**CITY OF ALBUQUERQUE  
PLANNING DEPARTMENT  
February 15, 2012  
DRB Comments**

**ITEM # 6**

**PROJECT # 1009125**

**RE: Lot 10 P-1, Rio Este Subdivision**

# Scaled Site Sketch -Rio Oeste Subdivision

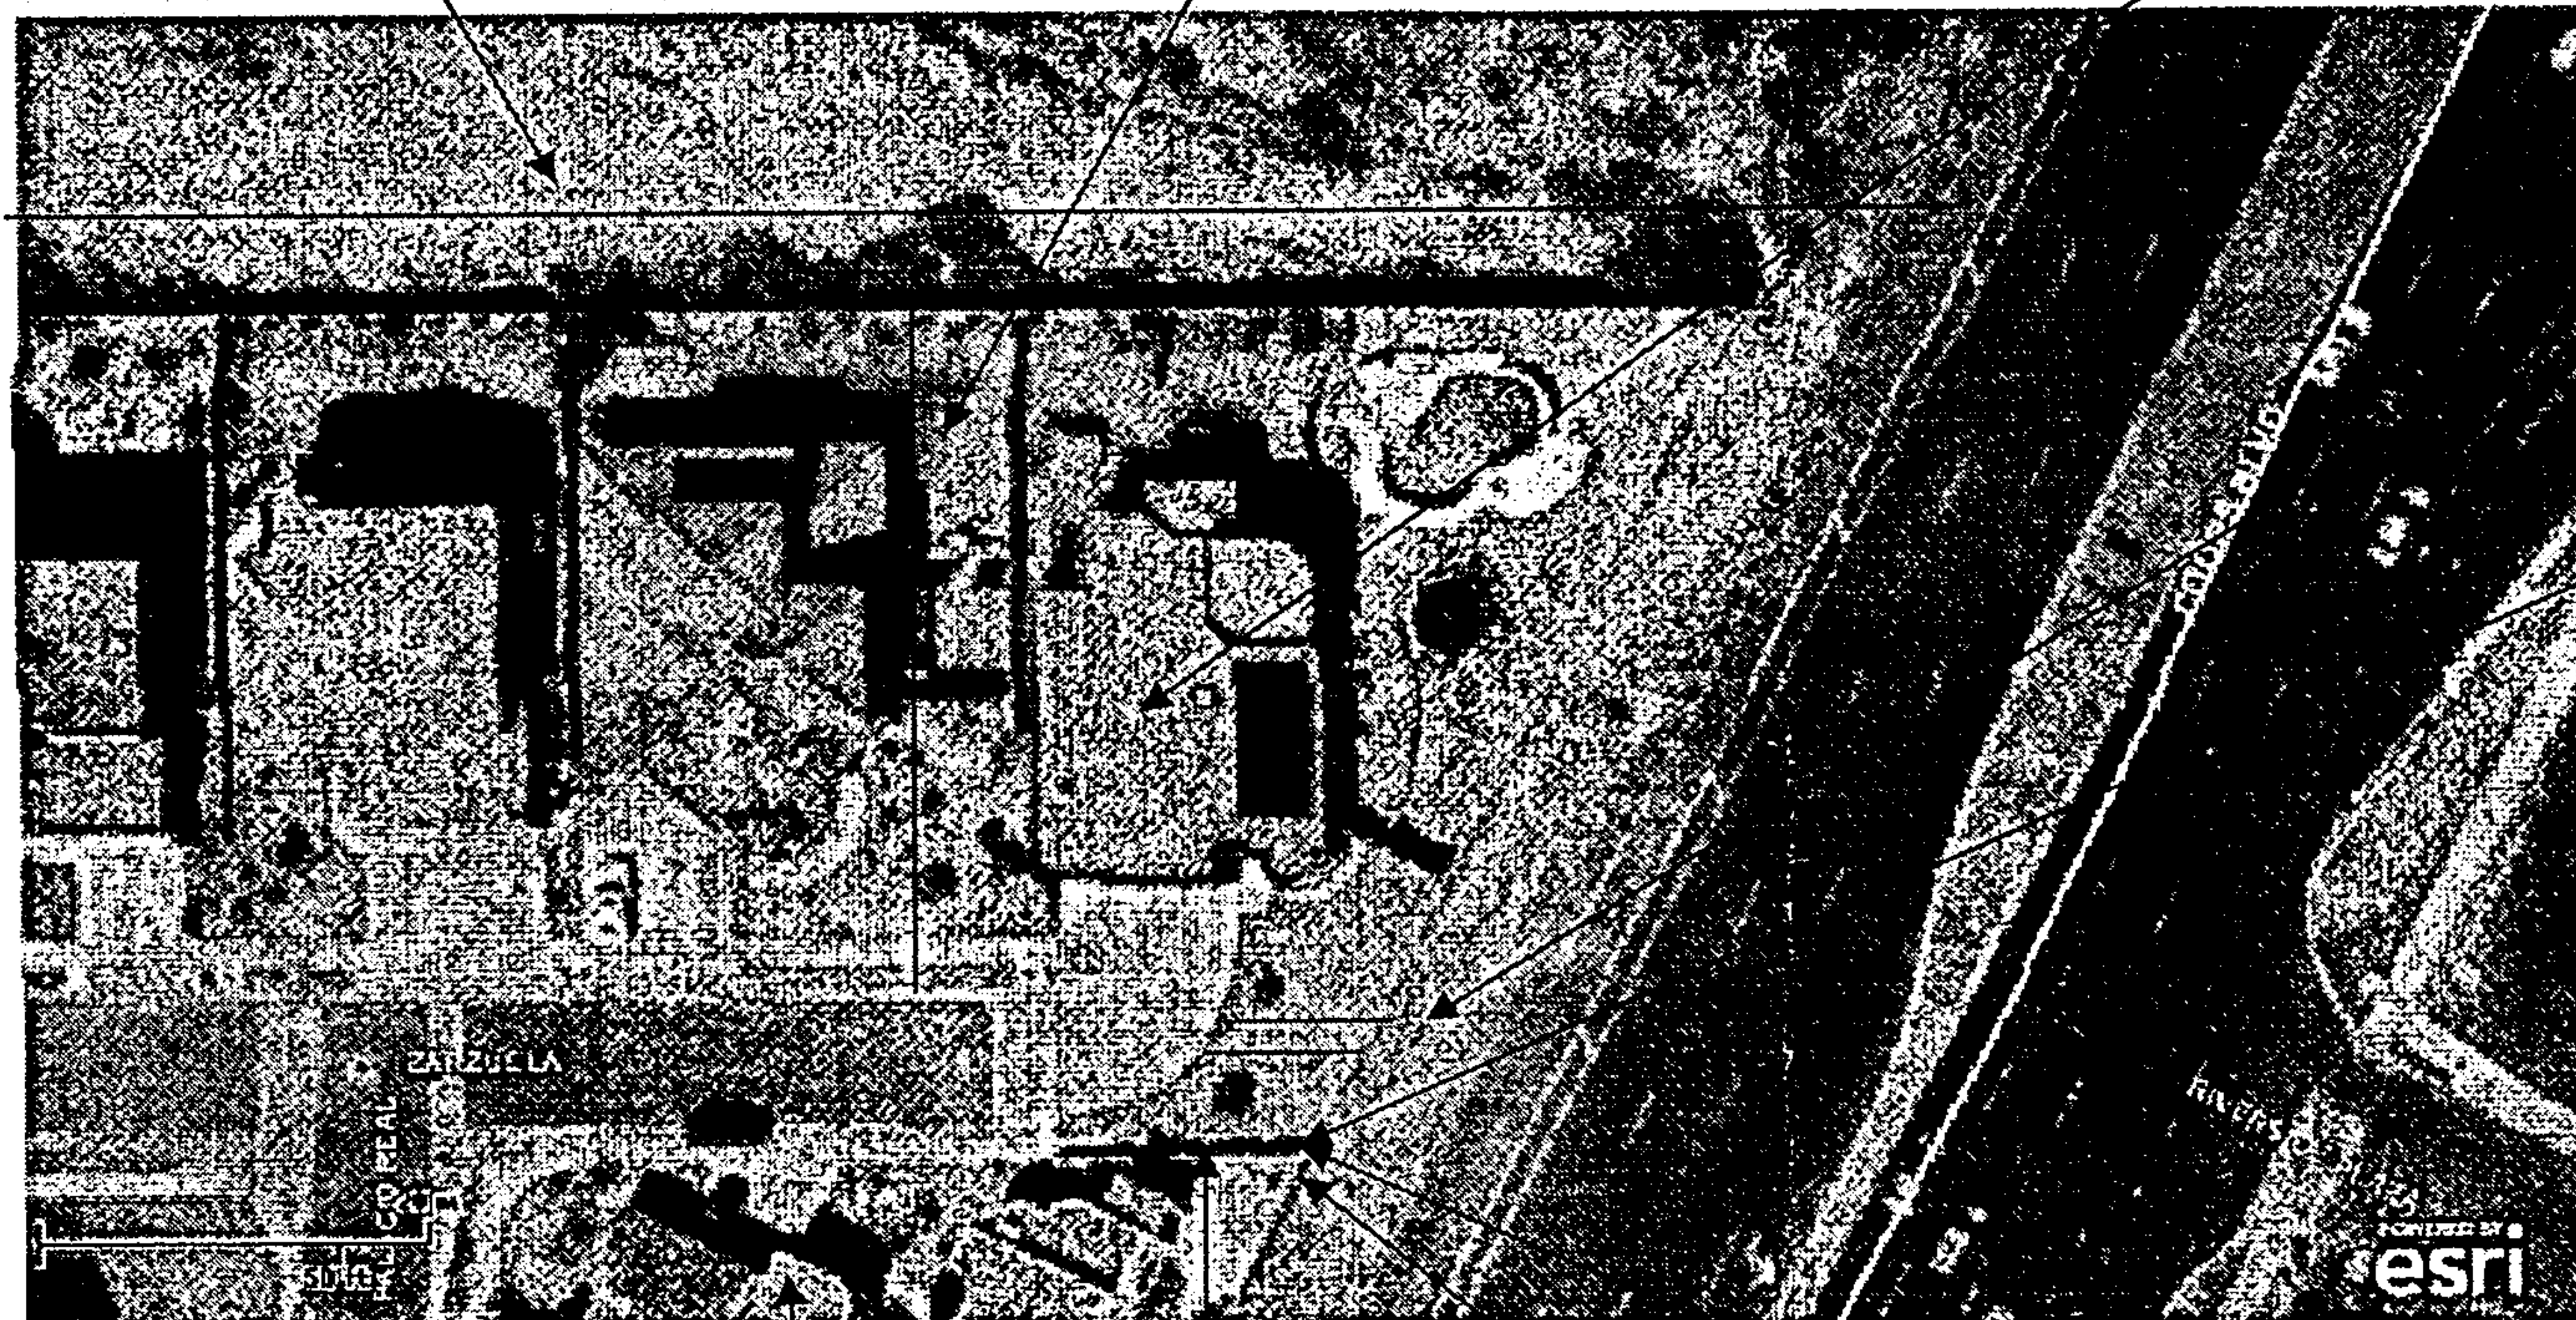
The referenced Public Access Easement is across Lot 10 P-1, and was platted in conformance with the Subdivision Ordinance Minimum Design Standards to have pedestrian access routes. It is not likely that easement would be vacated contrary to the ordinance. It is recommended that the access be controlled through a combination lock or keys issued to homeowners only.

In order to vacate the easement, an advertised public hearing by the DRB would be required after posting of signs; any decision by the DRB is appealable to the City Council. If the easement is approved for vacation Lot 10 P-1 would have to be replatted within one year to show the vacated easement.
